UNITED STATES PATENT AND TRADEMARK OFFICE

APPLICATION NO.	FILING DATE	FIRST NAMED INVENTOR	ATTORNEY DOCKET NO.	CONFIRMATION NO.
10/021,865	12/17/2001	W. Eli Strich	PA113B1C1	3128
23696 7590 02/07/2008 QUALCOMM INCORPORATED 5775 MOREHOUSE DR. SAN DIEGO, CA 92121			EXAMINER TORRES, JUAN A	
			ART UNIT 2611	PAPER NUMBER
			NOTIFICATION DATE 02/07/2008	DELIVERY MODE ELECTRONIC

Office Action Summary	Application No. 10/021,865	Applicant(s) STRICH ET AL.	
	Examiner Juan A. Torres	Art Unit 2611

Figure 3 in the present application is:

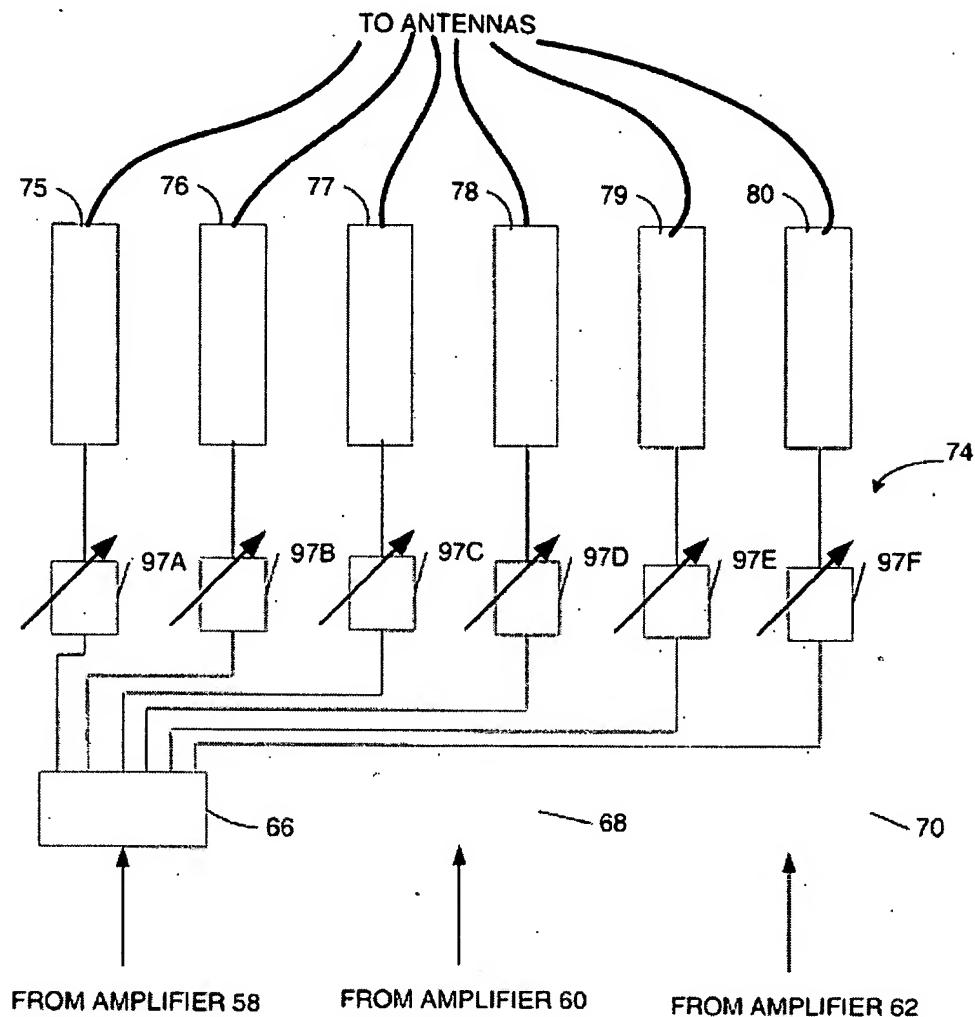
- a) In figure 3 blocks 68 and 70 are missing (see figure 3 in US6473447).

and, as indicated in the previous Office action, blocks 68 and 70 are missing from this figure.
